ADDENDUM DATE: April 21, 2022

ADDENDUM NO. 2

HARRIET'S HOPE

Addendum No. 2 to the Drawings and Project Manual, dated April 4, 2022, Harriet's Hope as prepared by Moody Nolan, Inc., 300 Spruce St. Suite 300, Columbus, OH 43215.

A811

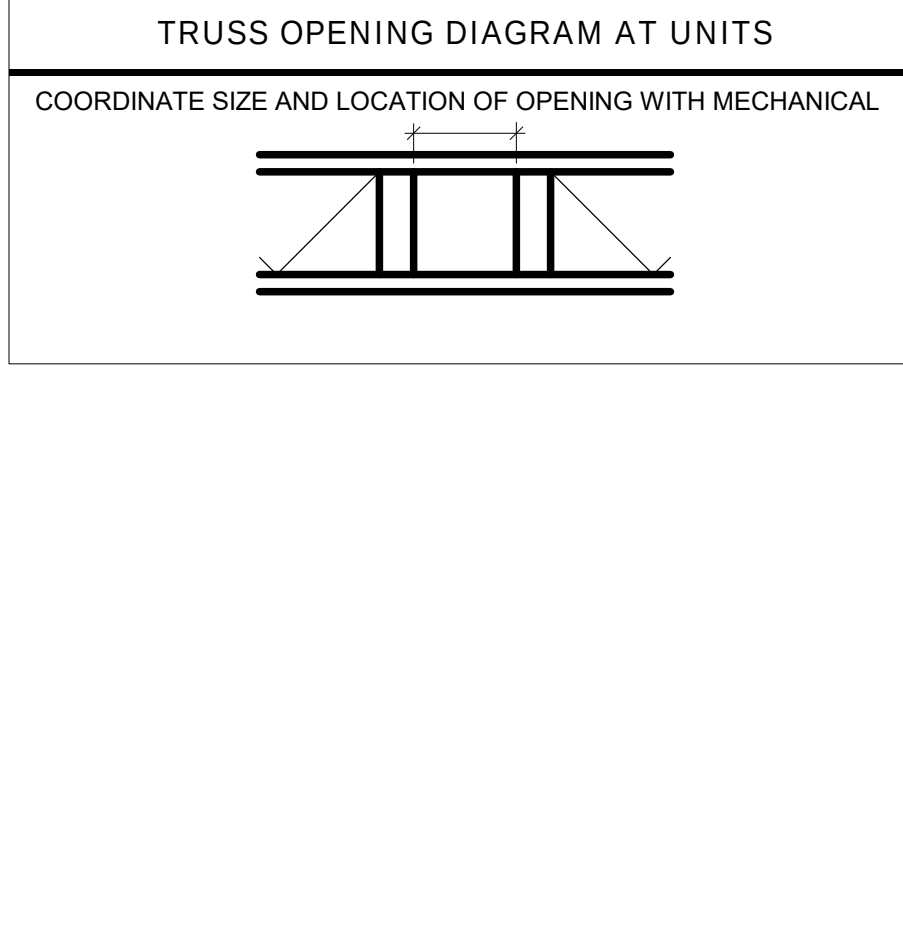
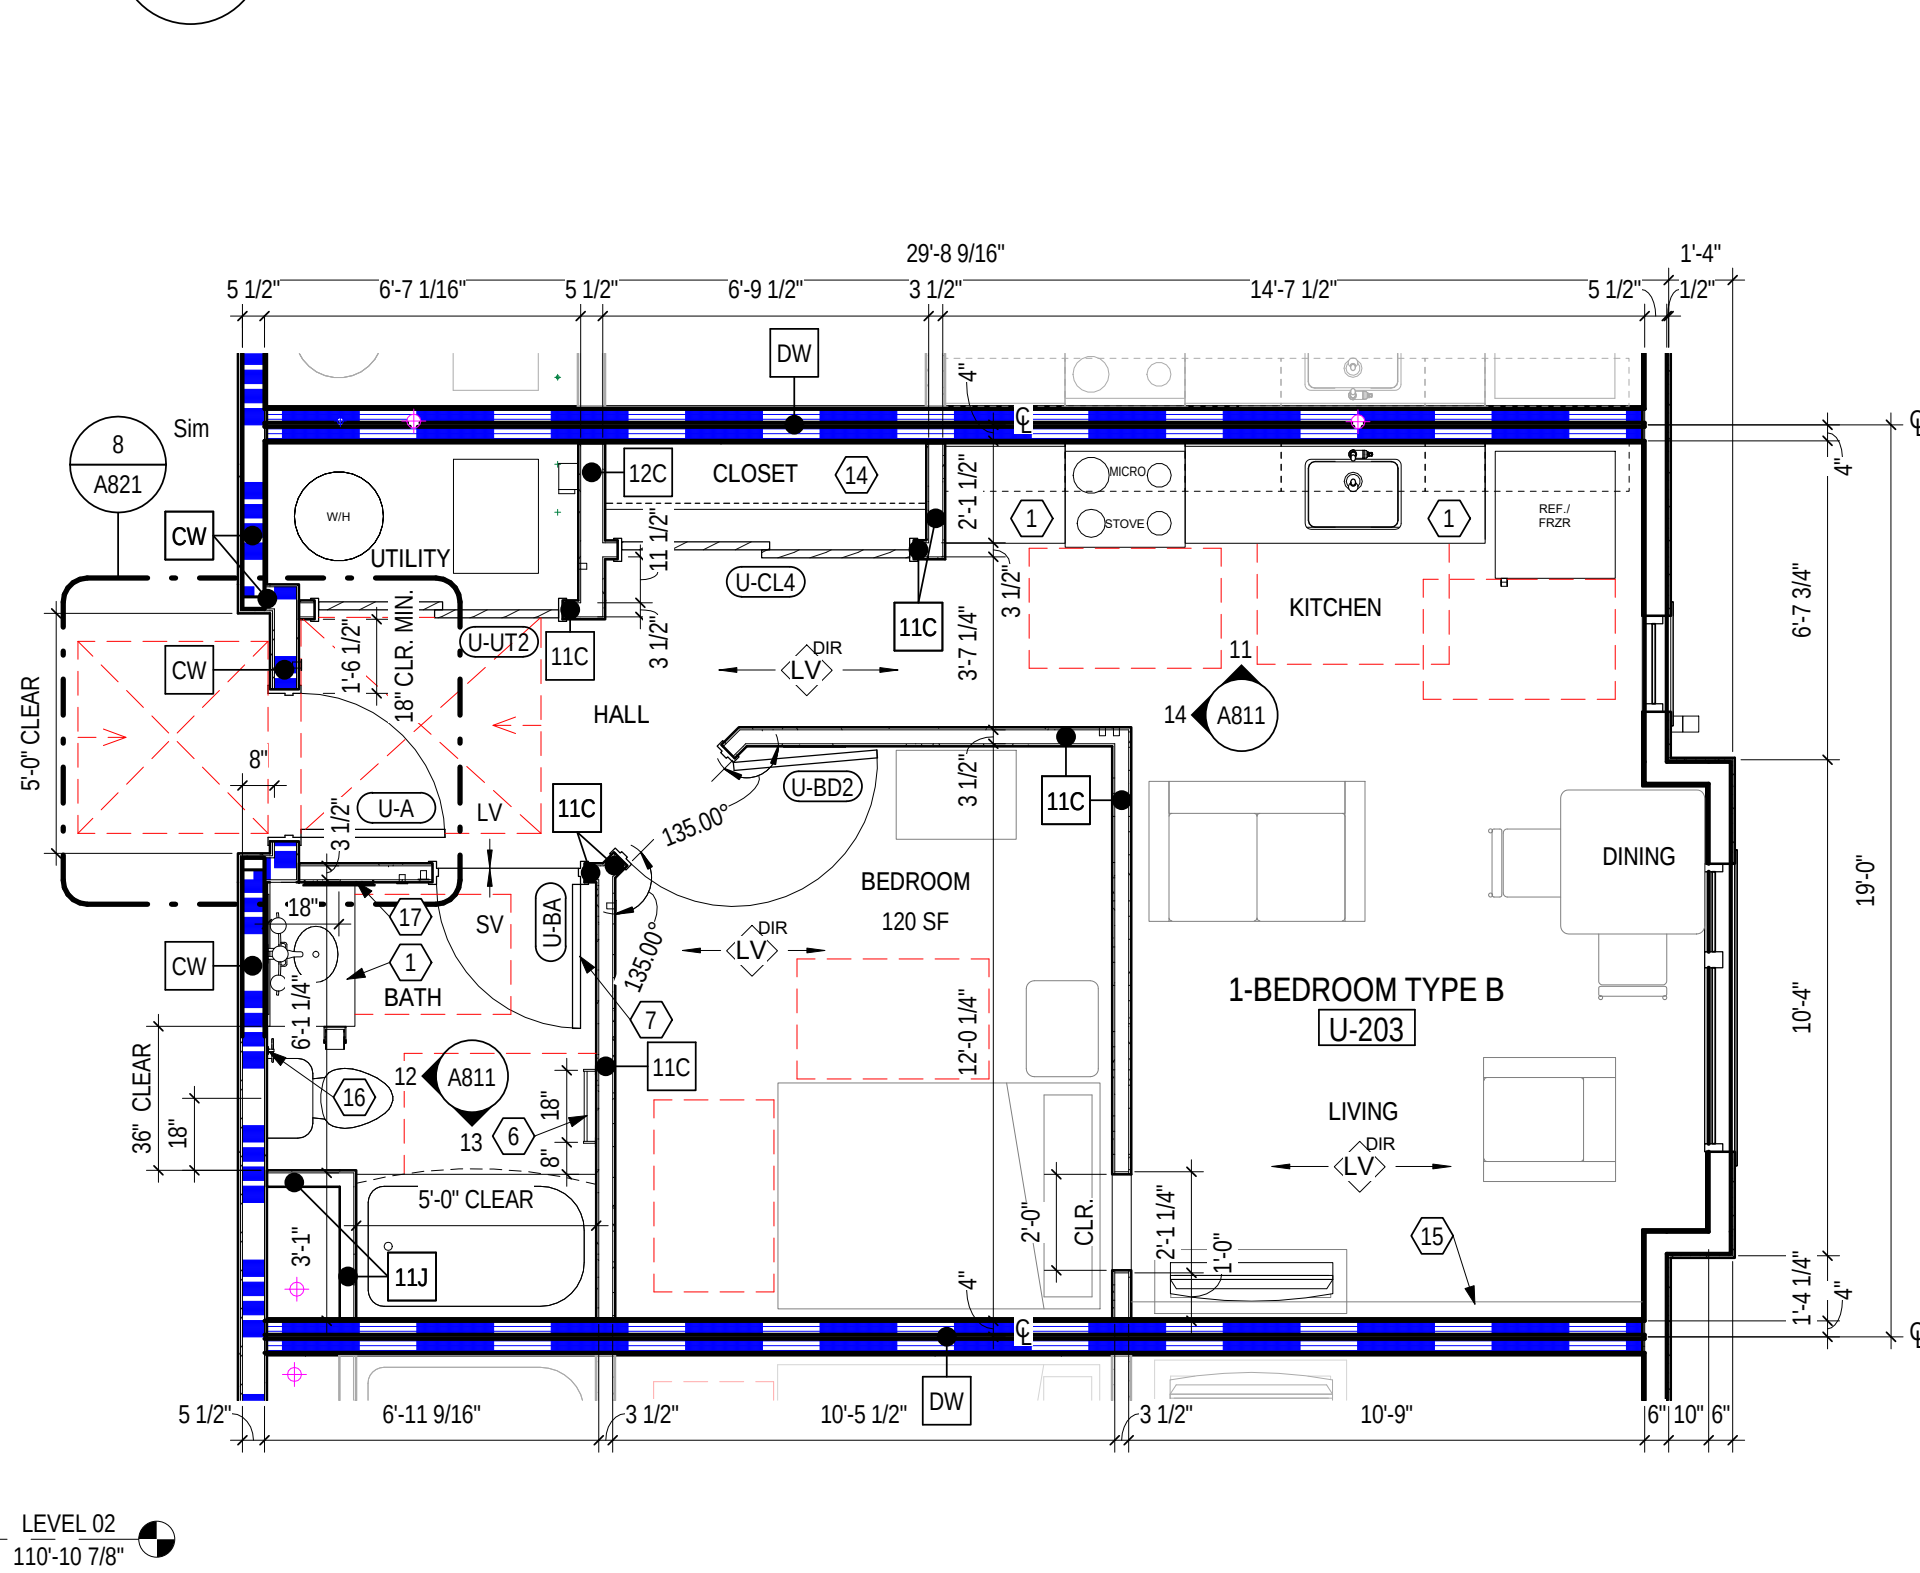
- H. A810 ENLARGED UNIT PLANS – 2 BEDROOM UNITS
 - 1. Typical Residential Door Schedule: **CHANGE** door U-A elevation to AT.
- I. A811 ENLARGED UNIT PLANS – 1 BEDROOM UNITS
 - 1. Typical Residential Door Schedule: **CHANGE** door U-A elevation to AT.
- J. A812 ENLARGED PLANS – COMMON AREAS
 - 1. **ADD** tackboard to west wall of Community Room CR-101.

4 DETAIL - WIFI ACCESS POINT AND MOUNTING
N.T.S.

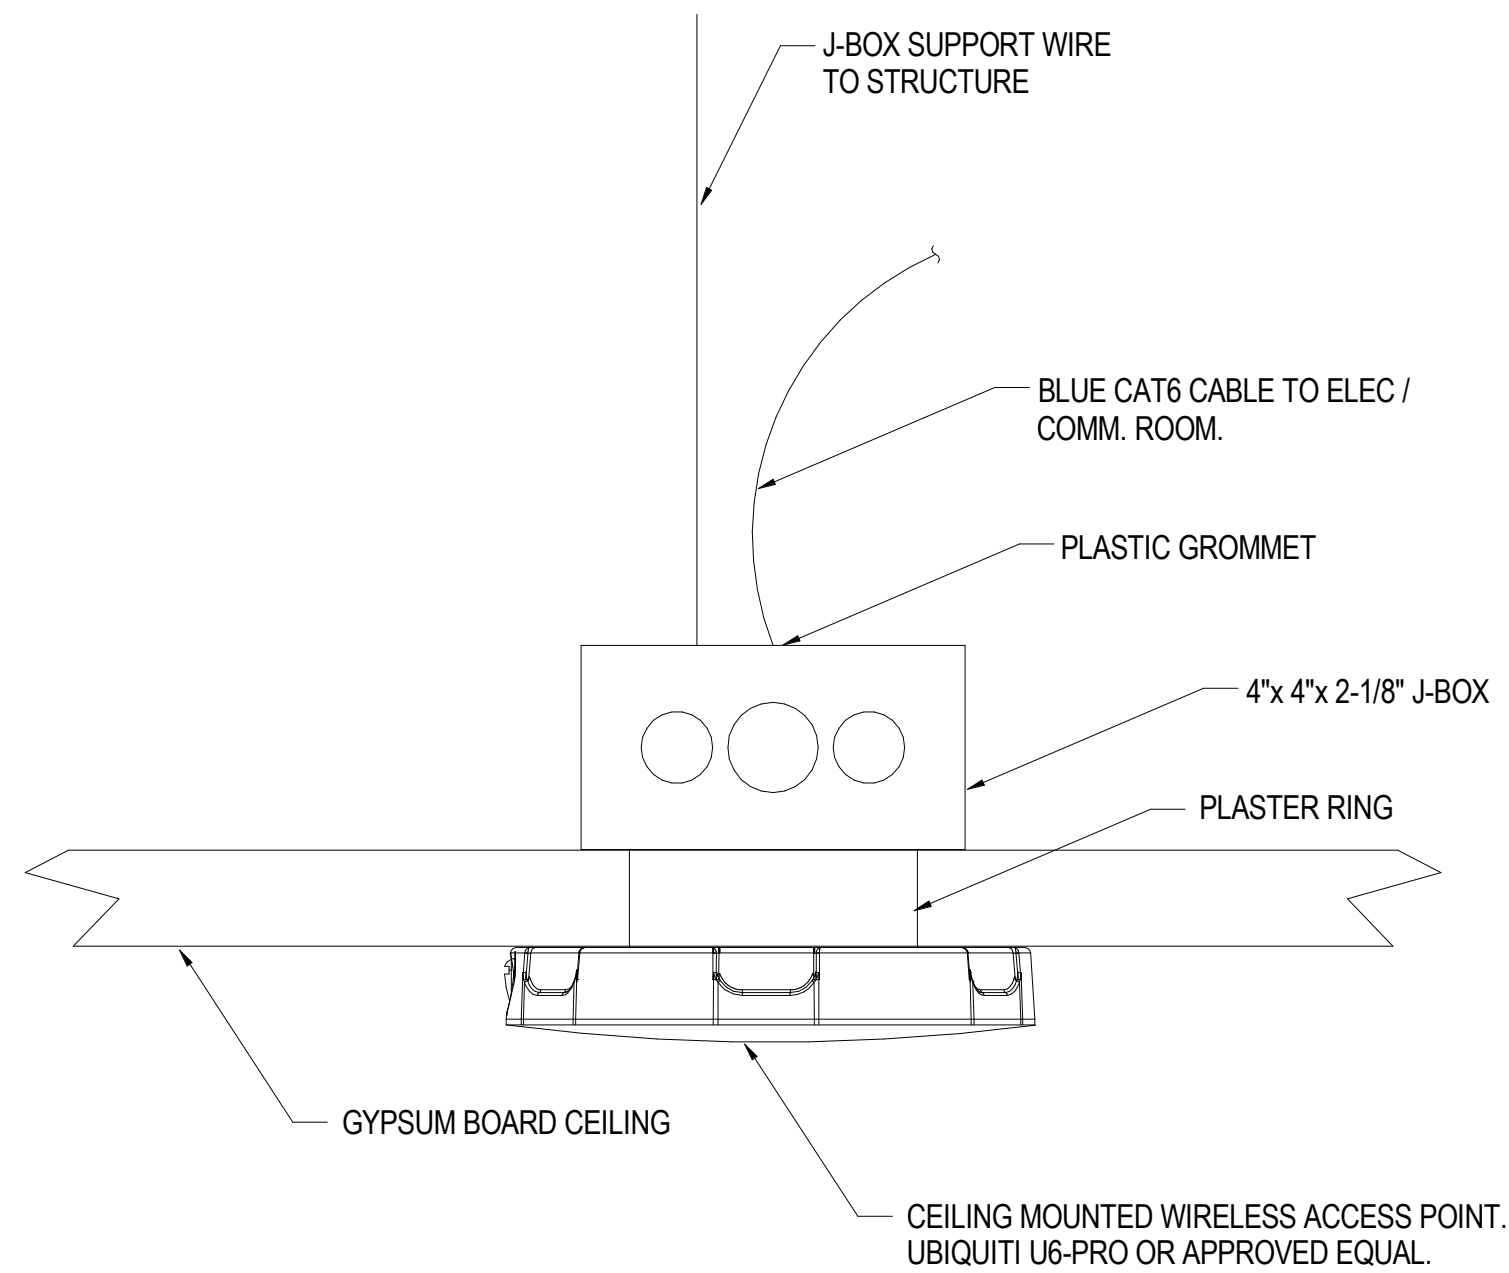
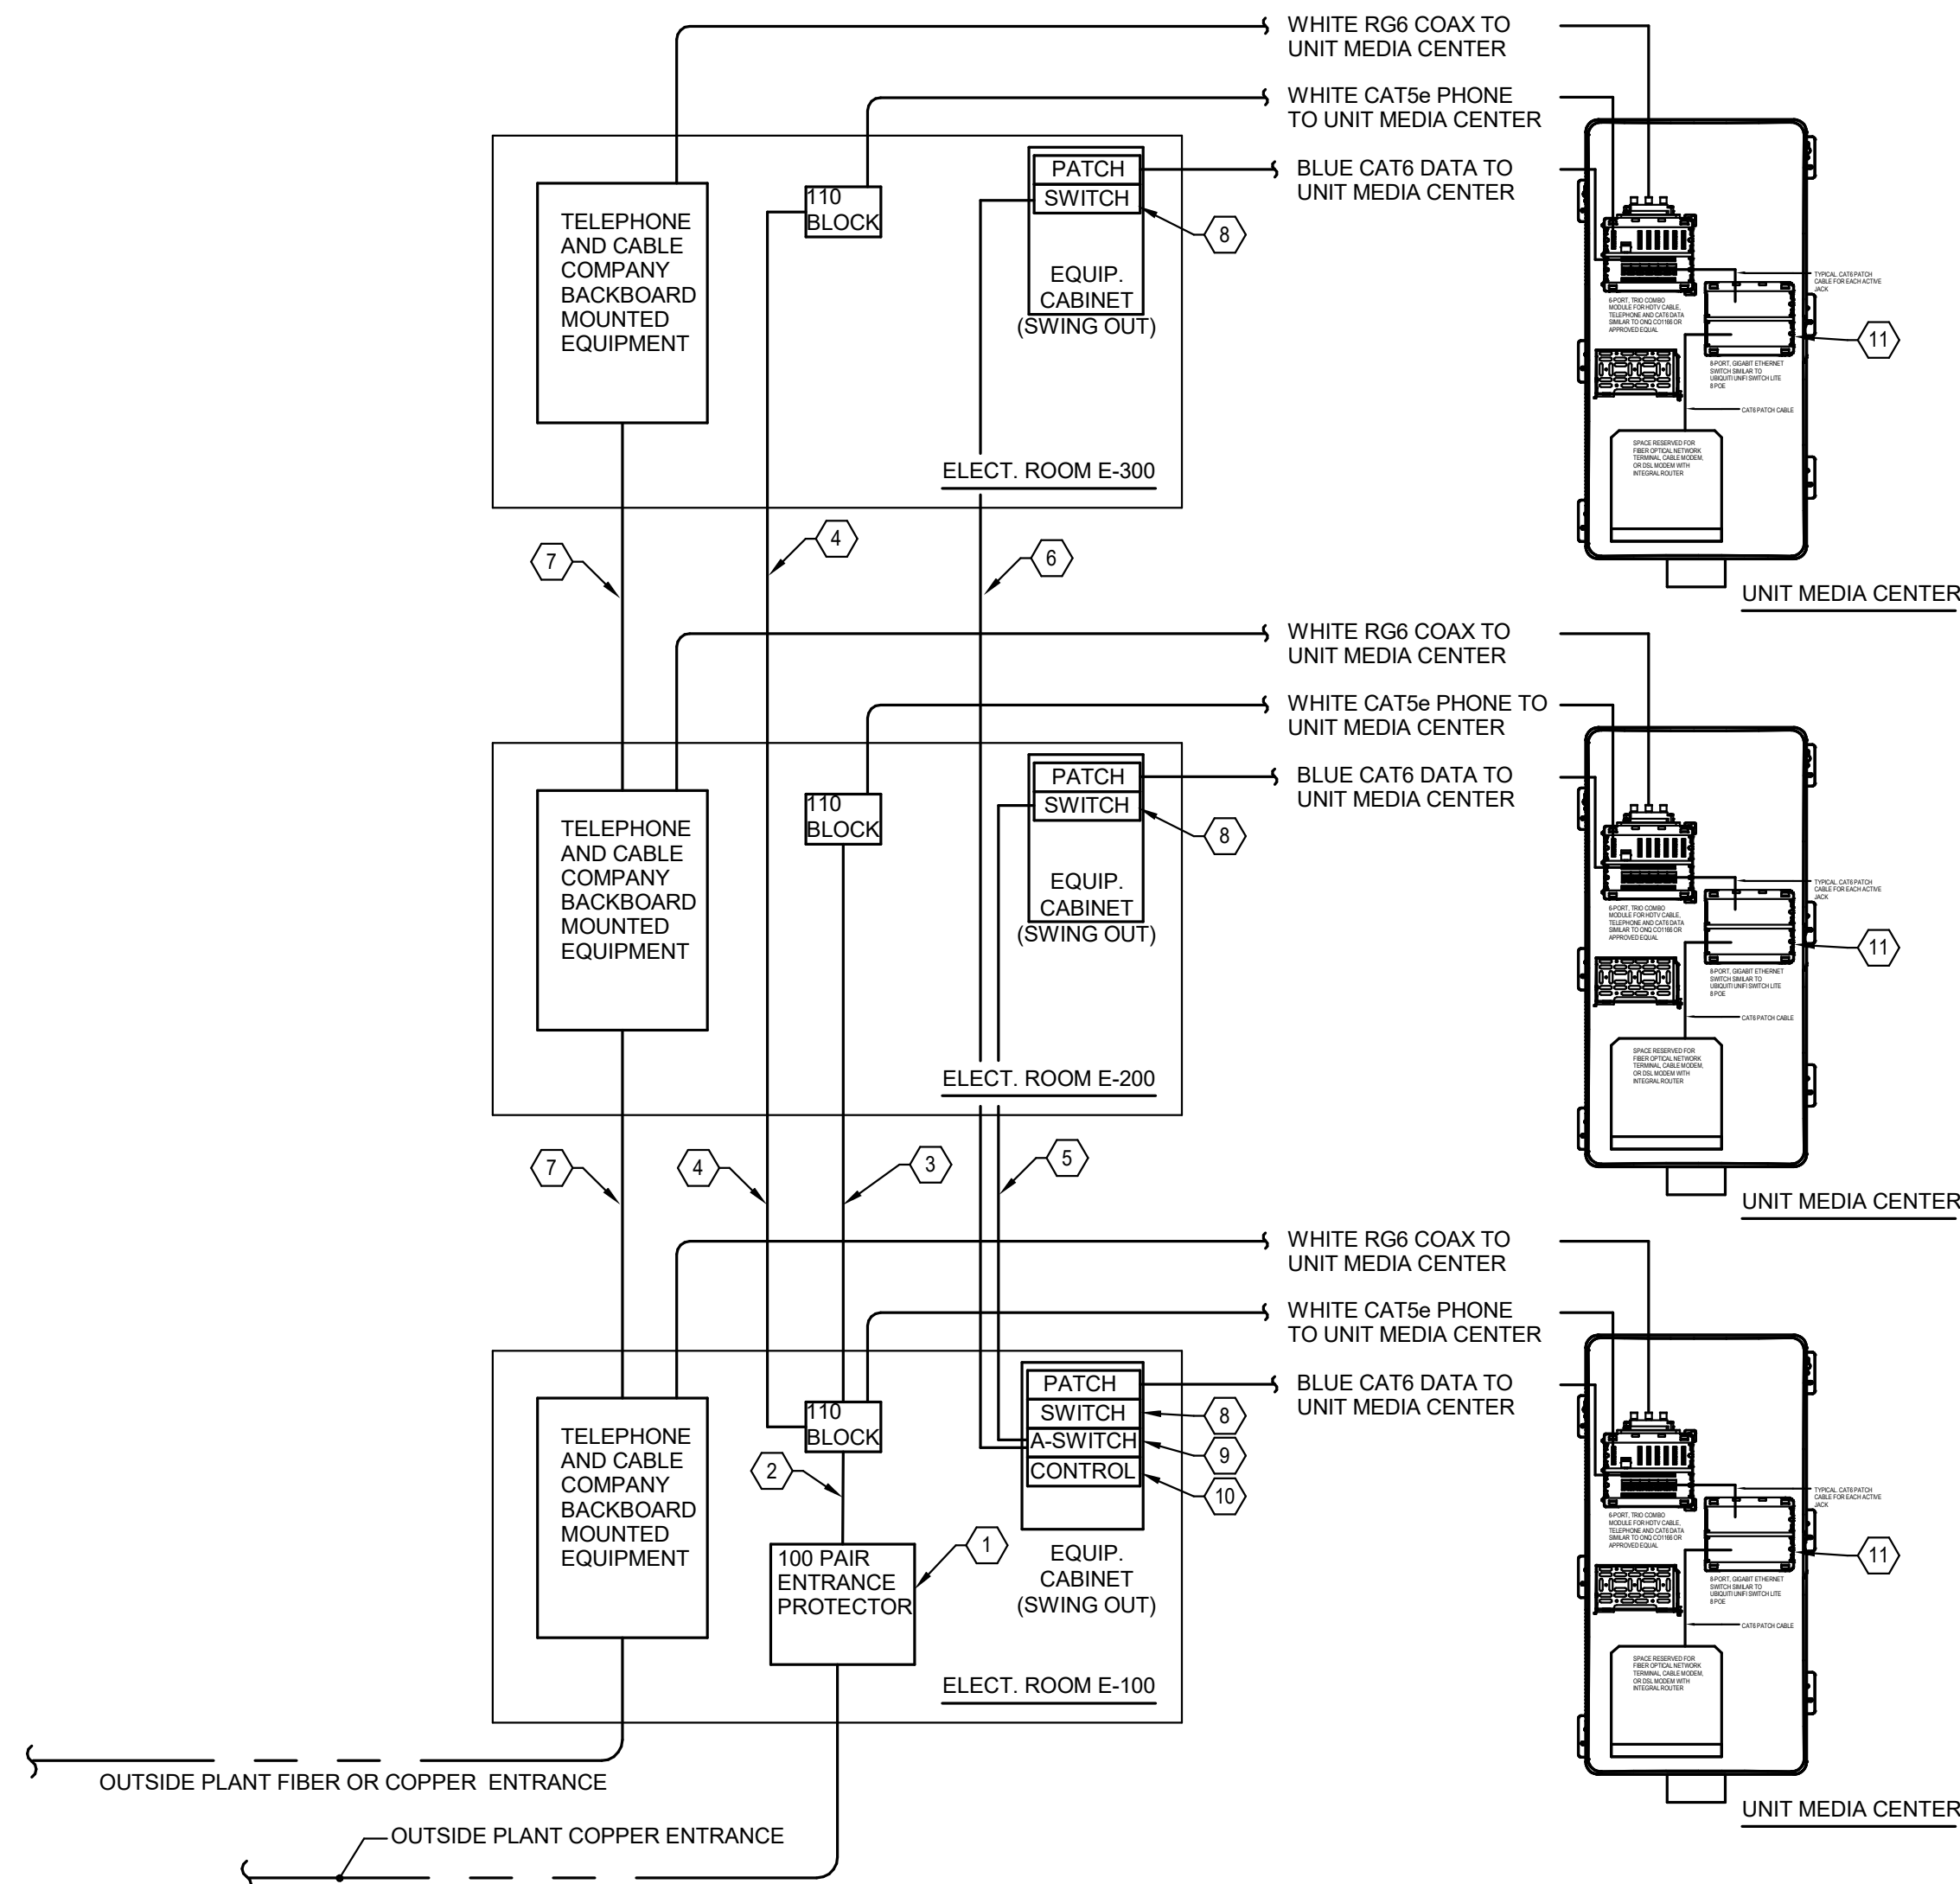
- A. T000 – GENERAL INFORMATION - SYSTEMS
 - 1. **UPDATED** Wifi symbol description in Technology Symbol's list.
 - 2. **UPDATED** two-way communication device in Fire Alarm Symbol's list
- B. T101 – LEVEL 01 – FLOOR LAN - SYSTEMS
 - 1. **UPDATED** symbol for two-way communication at elevator.
 - 2. **REVISED** coded note 15.
- C. T102 – LEVEL 02 – FLOOR LAN - SYSTEMS
 - 1. **UPDATED** symbol for two-way communication at elevator.
 - 2. **REVISED** coded note 15.
- D. T103 – LEVEL 02 – FLOOR LAN - SYSTEMS
 - 1. **UPDATED** symbol for two-way communication at elevator.
 - 2. **REVISED** coded note 15.
- E. T501 – DETAILS - SYSTEMS
 - 1. **REVISED** detail 2.
- F. T502 – DETAILS - SYSTEMS
 - 1. **REVISED** details 1 and 2.
 - 2. **ADDED** details 3 and 4.
